**Project Title** Whitney Family Residences **Project No. For City Use Only** 182513

**Project Address:**  
 2202 / 2206 Avenida De La Playa, La Jolla, Ca. 92037

DATE ISSUED: November 4, 2010 REPORT NO.: 10-150  
ATTENTION: Council President and City Council  
SUBJECT: WHITNEY MIXED USE, Project No. 182513; Council District I  
Process 5, Environmental Determination Appeal.  
REFERENCE: Report to the Planning Commission No. PC-10-079, Sept. 9, 2010

FIGURE 1

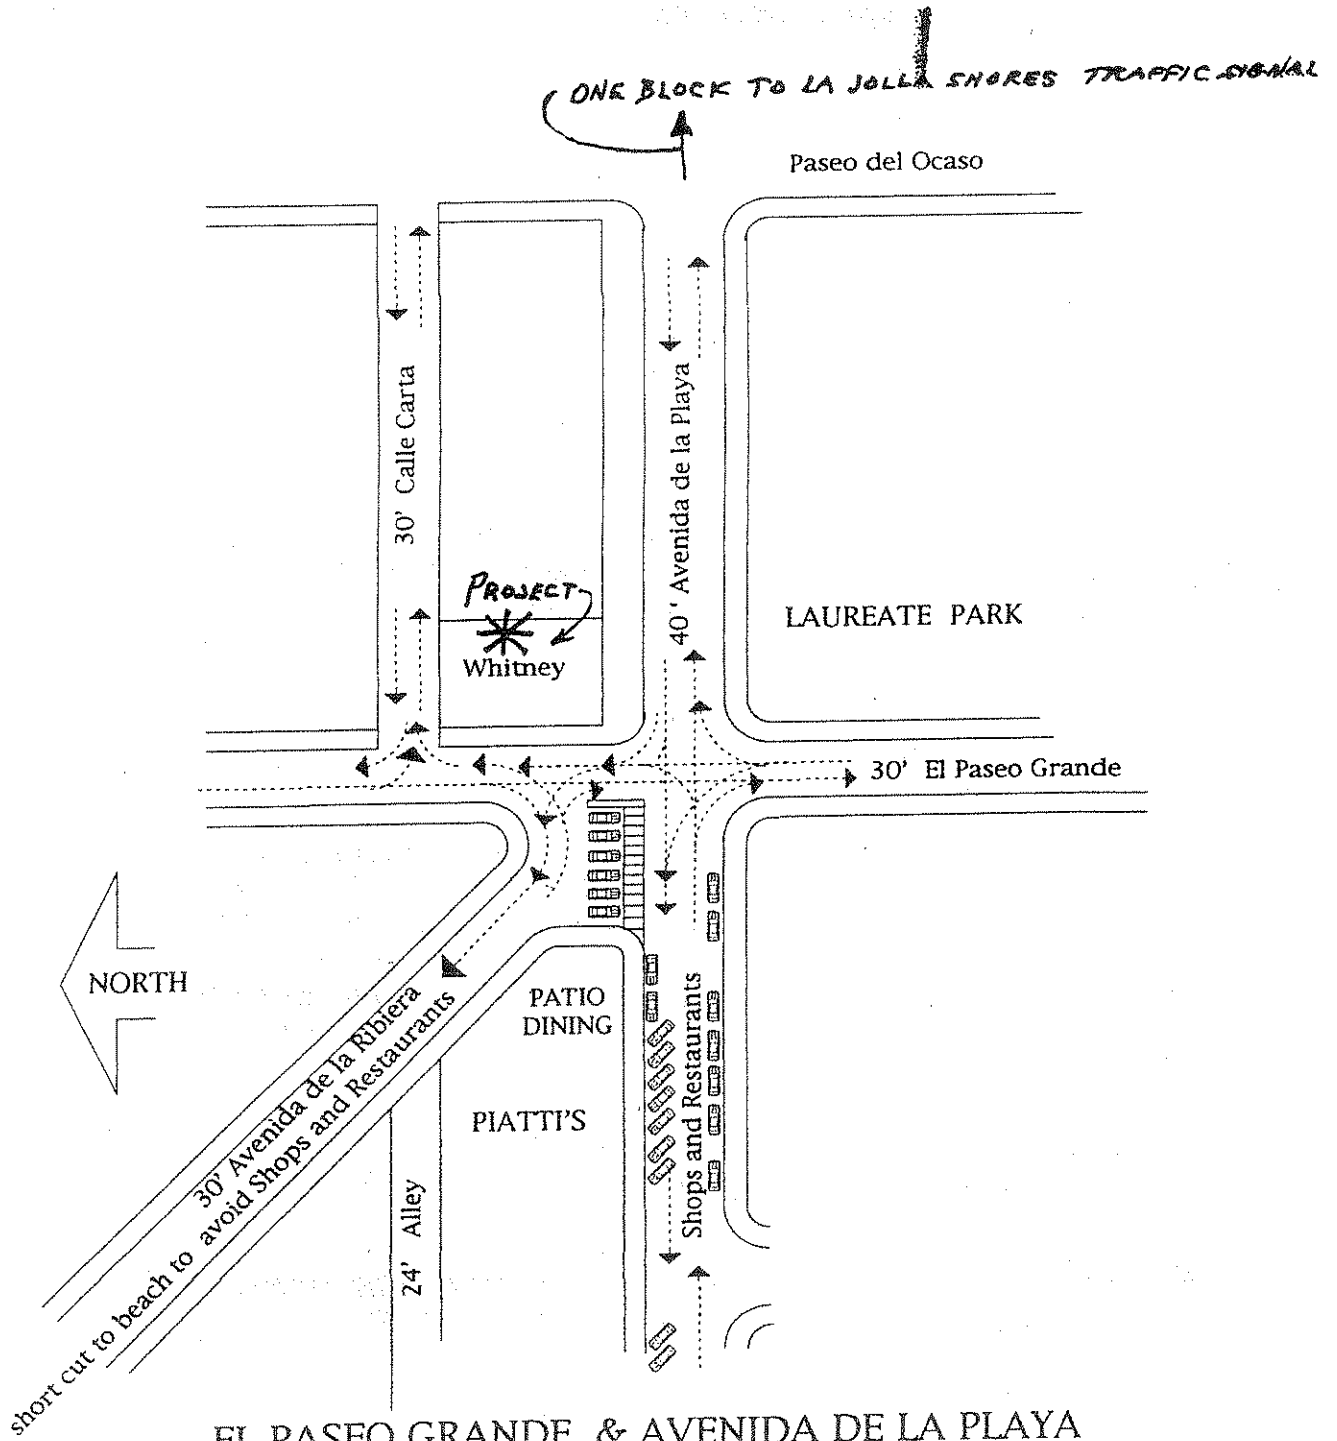
Figure 1 locates the Whitney Multi-Use project. Note that though it fronts on the 40 foot wide pavement at 2202 and 2206 Avenida De La Playa, it has side street frontage along El Paseo Grande (30 feet wide) and rear access along 30 feet wide, Calle Clara. All vehicle driveway access is to/from Calle Clara.

FIGURE 2

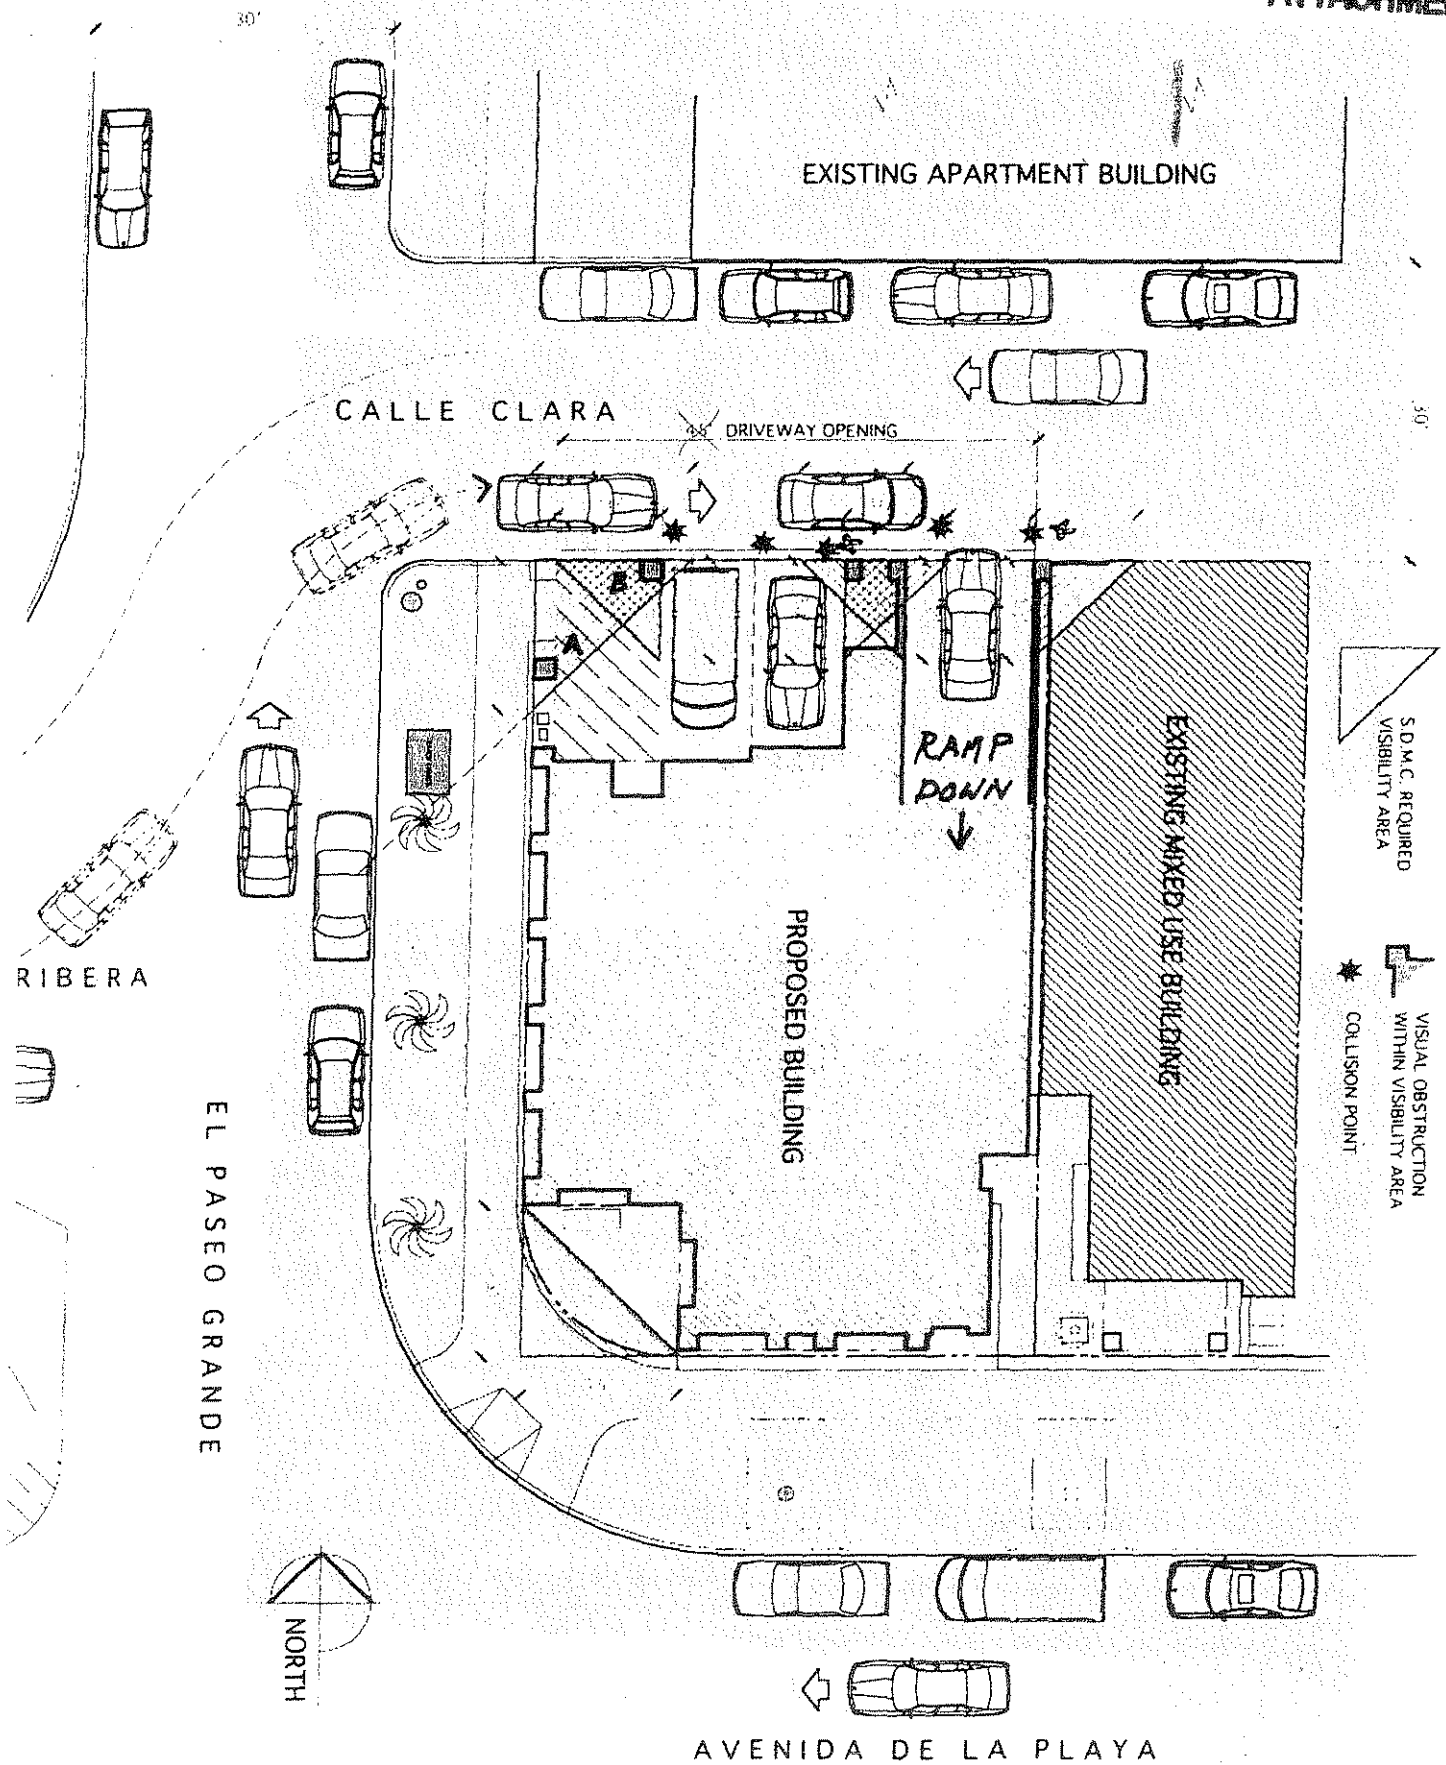
Figure 2 shows the proposed ground floor site plan of the Whitney building and shows the Calle Clara street driveway access. Note that two of the driveways are for parking two vehicles while the furthest east one is for the ramp to/from five, underground, parking spaces (7 total off-street spaces).

According to SDMC Sec. 113.0273 (c), driveways intersecting a street must have 10 feet sight visibility triangles on each side of the driveway. (Also see Figure 4 for driveway sight triangles entering a street) Note on Figure 2 that because of location and the four support columns for the upper floors, none of the driveways, or ramp, has the required sight visibility triangles.

As noted above, the eastbound traffic lane of Calle Clara, is up against the south curb. Thus vehicles leaving the parking spaces or ramp, without the sight visibility triangles, must be past the curb into the travel lane, before they can see oncoming vehicles, bikes, or pedestrians in the travel lane. This is positively a real traffic safety issue with the driveways shown on Figure 2 and the four support columns as shown.

Figure 2 shows that, a ramp vehicle would have a particularly hard time exiting since the top of the ramp will be very close to the curb line. Thus the driver will be near the curb line with the hood and windshield in the travel lane, before the driver can see oncoming vehicles, etc. This is a serious traffic safety issue and the prime reason the City of San Diego has adopted the LDC Sections 113.0103, 113.0273 and 113.0246. For traffic safety, the visibility triangles must be provided along Calle Clara so drivers can see into the travel lane before their vehicle enters it.

It is strongly recommended for existing and future traffic safety along Calle Clara, that the support columns shown along Calle Clara on Figure 2 be eliminated some way, or relocated, so that the 15 x 15 foot sight triangle at the intersection can be implemented along with the 10 x 10 foot driveway and ramp sight triangles along the Calle Clara street frontage. This means that within the 15 x 15 intersection sight triangle and east of this along Calle Clara within 10 feet of the south curb, there should be no columns, posts, walls, or doors for the Whitney Building, that will encroach on the 10 x 10 foot sight triangles. Without the required visibility triangles the Whitney Building will have a significant negative impact on the safety of vehicles, pedestrians, and bicycles in the area due to poor sight distance.
